Re: C16-2013-0017; 6406 IH 35 Southbound Service Road; Sign Variance Request  
for The Linc

**Exhibit A to Variance Application**

**REVISED 10/01/14**

## Site Signage Locations

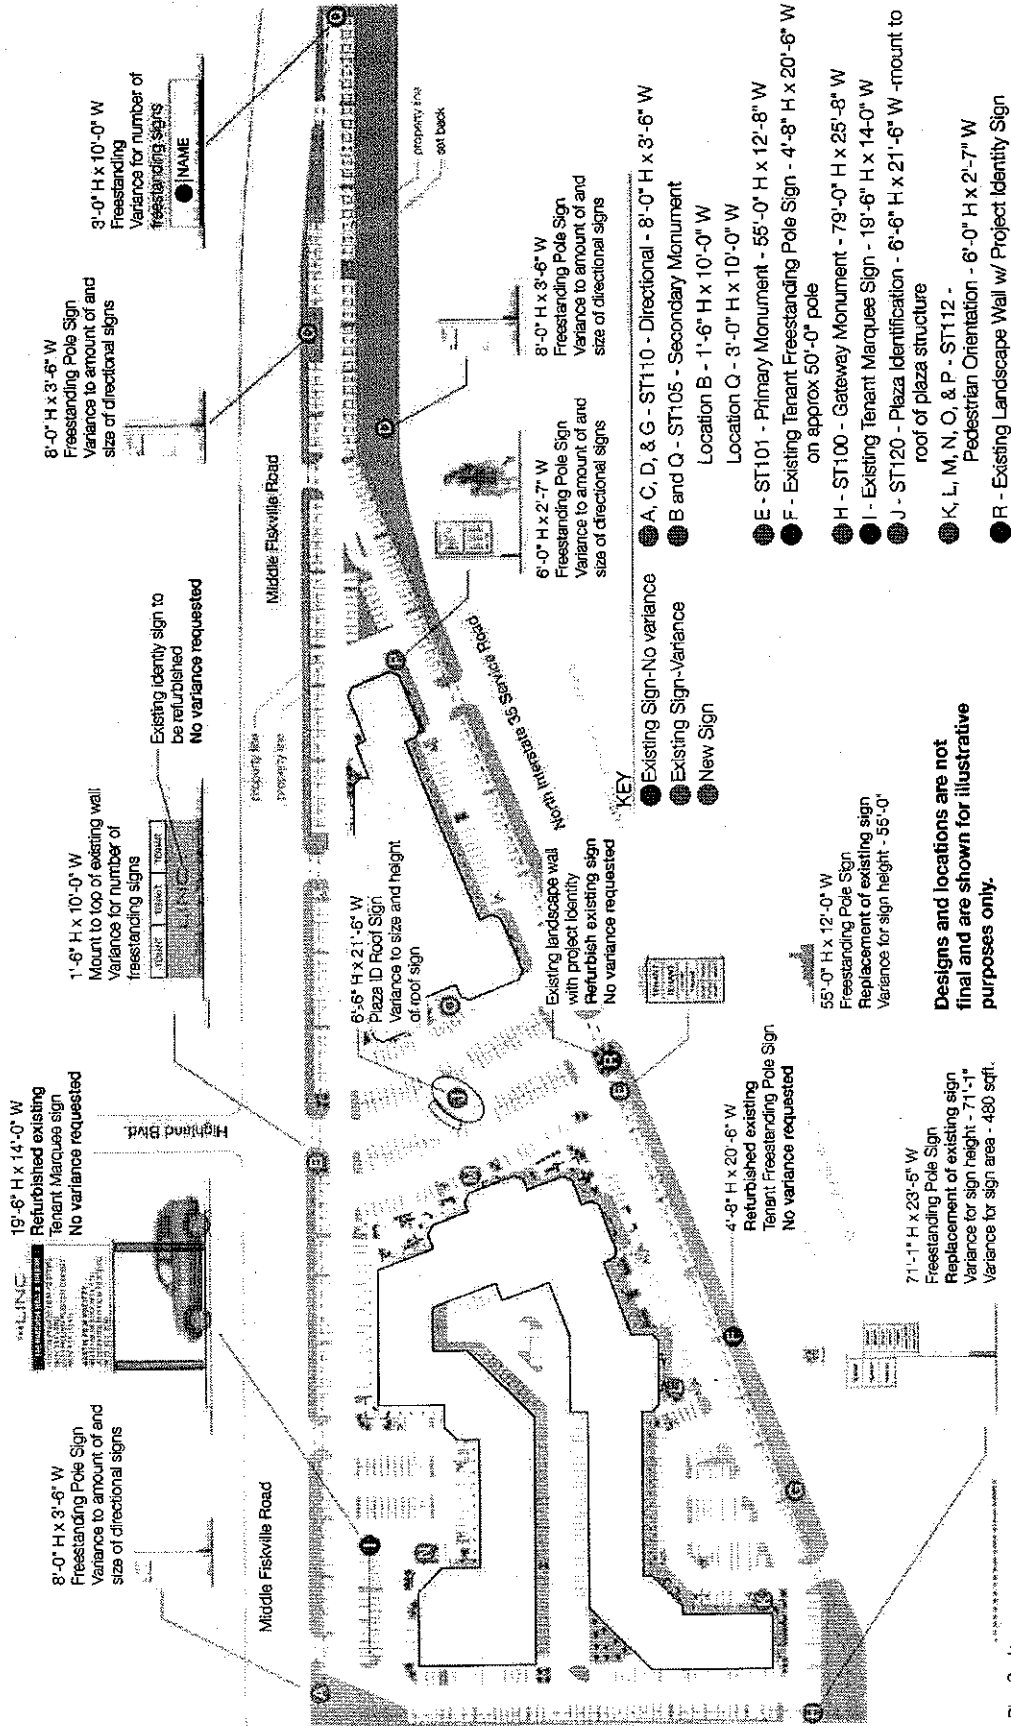
**I. Section 25-10-101 (C)(1) (*Signs Allowed In All Sign Districts Without An Installation Permit*)** to increase the number of freestanding or wall signs allowed per curb cut from 1 (required) to 2 (requested). Variance is applicable to sign locations A, C, D, G, K, L, M, N, O, and P. Locations A, C, D, & G are vehicular directional located on the perimeter of the site. Locations K, L, M, N, O, & P are Pedestrian Orientation (map and directory) signs located on interior of site.

**II. Section 25-10-101 (C)(2) (*Signs Allowed In All Sign Districts Without An Installation Permit*)** to increase the maximum sign area from 12 feet (required) to 15 feet (requested). Variance is applicable to sign locations A, C, D, & G. These signs are vehicular directionals located on the perimeter of the site.

**III. Section 25-10-101 (C)(2)(a) (*Signs Allowed In All Sign Districts Without An Installation Permit*)** to increase the maximum height of a freestanding sign from 4 feet above grade (required) to 8 feet above grade (requested). Variance is applicable to sign locations A, C, D, G, K, L, M, N, O, and P. Locations A, C, D, & G will have a maximum height of 8'-0". Locations K, L, M, N, O, & P will have a maximum height of 6'-0"

**IV. 25-10-123 (B)(1) (*Expressway Corridor Sign District Regulations*)**, to increase the number of freestanding signs allowed on a lot from 3 (required) to 7 (requested)(6 of which are already existing). Existing freestanding sign locations on site are: B, E, F, H, I, & R.  
New freestanding sign location on site is: Q.

**V. 25-10-123 (B)(2) (*Expressway Corridor Sign District Regulations*)**, to increase the maximum allowed sign area from the lesser of 300 sq. ft. or 0.7 square feet for each linear foot of street frontage (required) to ~~600~~ 480 sq. ft. (requested). Variance is applicable to sign location H.

**VI. 25-10-123 (B)(3) (*Expressway Corridor Sign District Regulations*)**, to increase the maximum allowed sign height from the greater of 35 feet above frontage street pavement grade or 20 feet above grade at the base of the sign (required) to ~~80~~ 71'1" feet above frontage street pavement grade (requested). Variance is applicable to sign locations E & H.

IX. 25-10-132 (C) (*Roof Sign Instead of Freestanding Sign*), to increase the maximum height permitted for a roof sign from the lesser of either 5 feet above the building façade or 5 feet above the maximum height permitted for a freestanding sign (required) to the lesser of either 8 feet above the building façade or 8 feet above the maximum height permitted for a freestanding sign (requested). Variance will apply to location J.
